NEW AUTOMATIC TRANSMISSION FLUID (ATF-A7)

Service Alert No.: SA-063/22

2023 Mazda3 (with cylinder deactivation)

2023 CX-30 (with cylinder deactivation)

1	Dipstick
2	"A7"

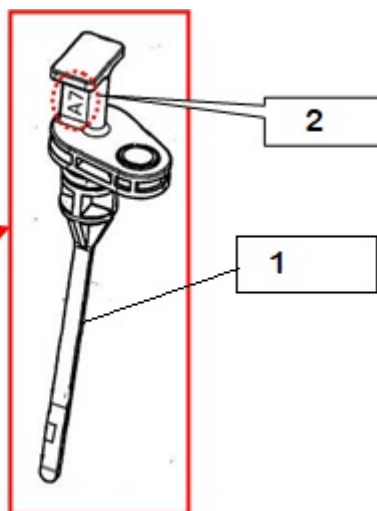
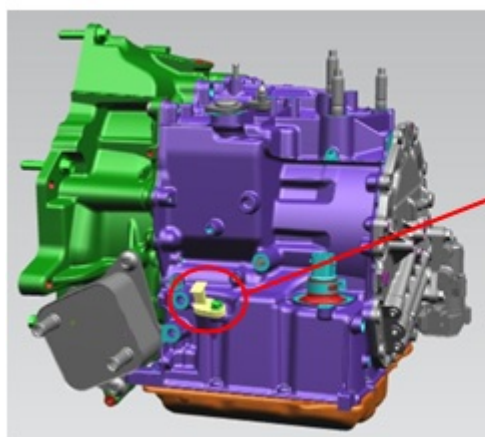
For the ATX that requires ATF-A7, “A7” is marked on the dipstick as shown.

NOTE: The dipstick is marked "FZ" for "FZ" ATF use and any ATF other than "ATF-FZ" cannot be used.
